NRC RESOLUTION OF LICENSEE COMMENTS

Licensee's Post Written Examination Comments Publically Available
in ADAMS Accession No. XXX

Oyster Creek Generating Station
Facility Operating License No. DPR-16
NRC Docket No. 50-219

Subject: Third Supplemental Submittal of Initial License Training NRC Written
Examination Grading

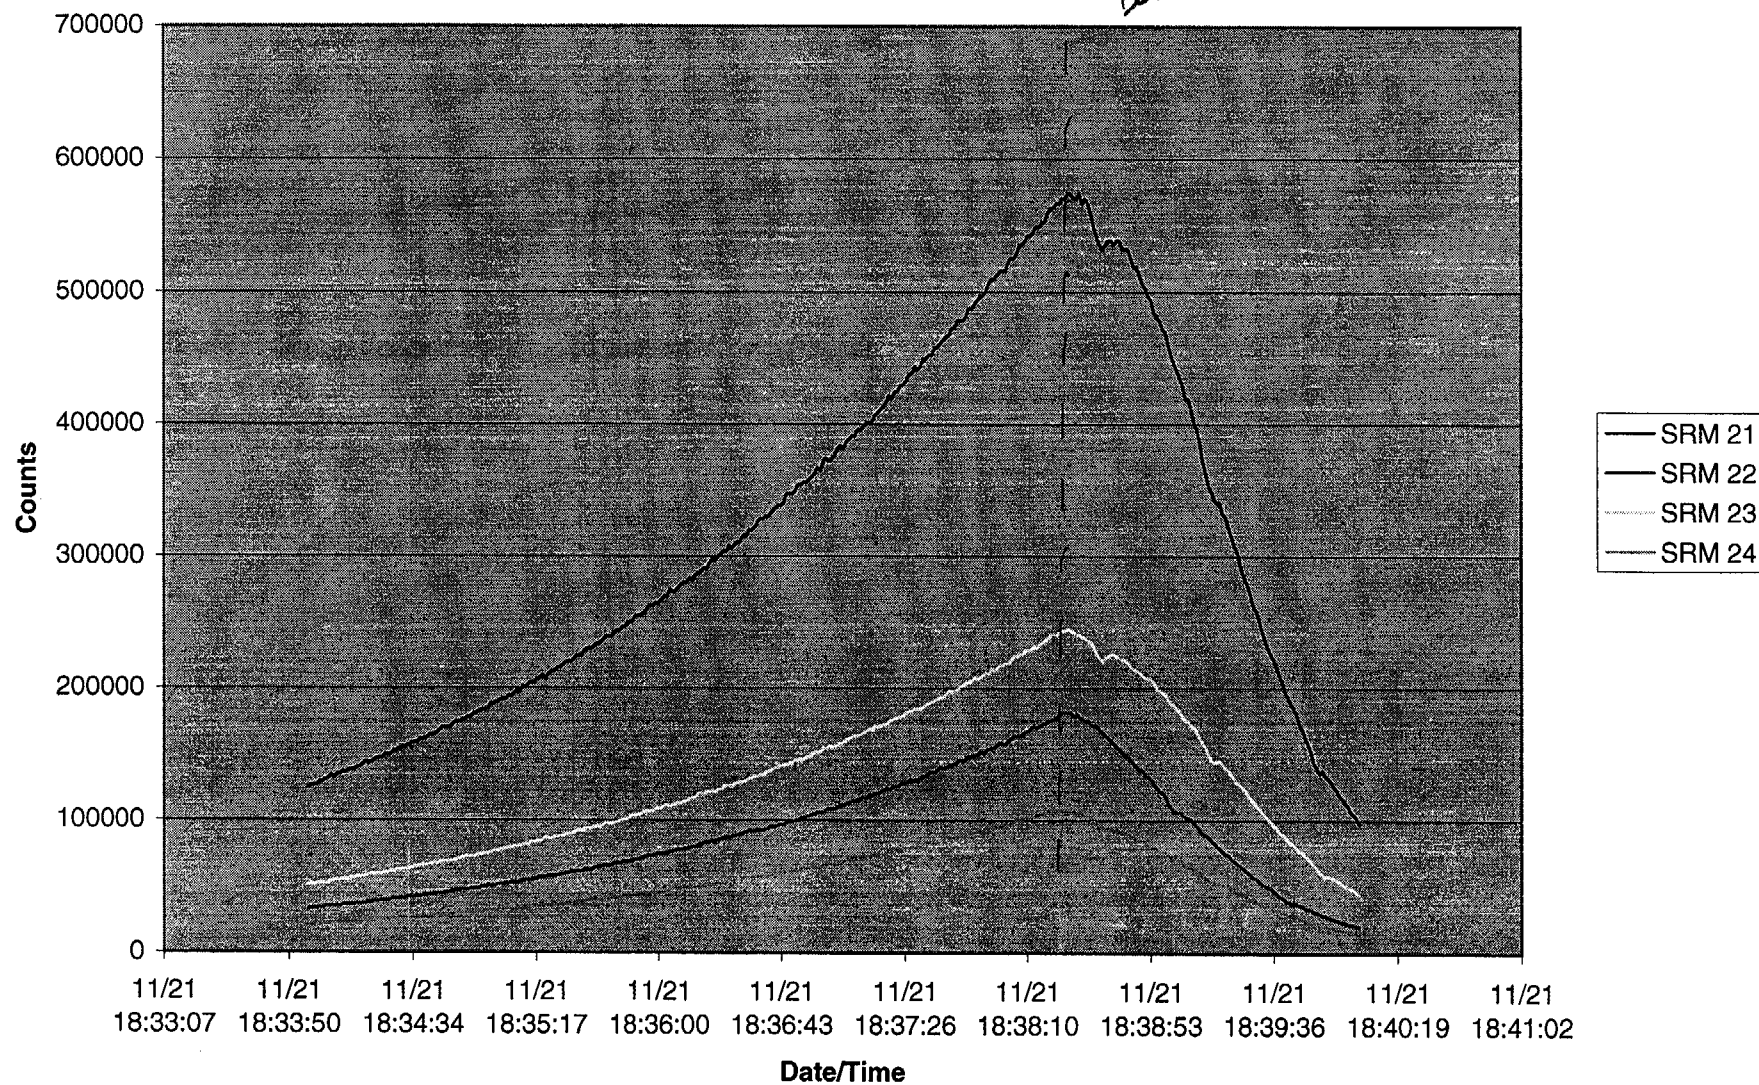
We are including a graph of the most recent reactor startup following our refueling outage. The graph shows all 4 SRM counts as a graphic plot. All four detectors were pulled when IRMs were above 50% of range 1 per procedure, and the plots show each SRM counts dropping as the detectors are being withdrawn. With SRM counts dropping, a negative period would be seen.

As SRM detectors are initially withdrawn, the move further away from a higher flux area of the core causing period to become longer.

Oyster Creek changed the correct answer to **C**

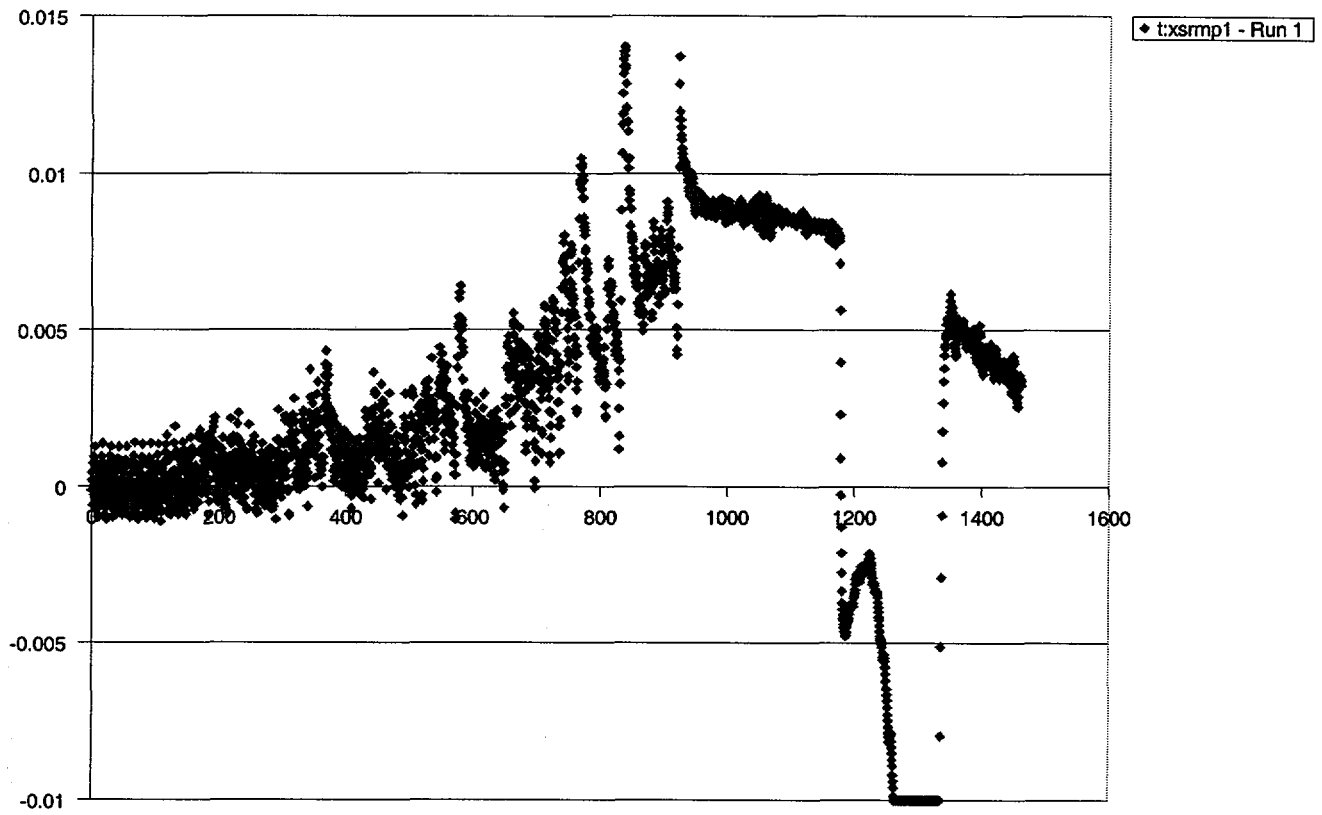
We pulled rods to achieve a constant period of approximately 80 to 100 seconds. At time 1176.9 seconds, the SRM detectors were all withdrawn from the core. This corresponds to the sharp downward trend in period. If you place your computer cursor over that point in each of the period graphs, it will show the data point and time taken. The SRM counts started a downward trend approximately 3 seconds after the SRM detectors were moving outward. The SRM detectors were then stopped when the counts reached approximately 1E4 cps, per procedure. On the IRM detector plots, the sharp downward trends denote when each detector range switch is being ranged up.
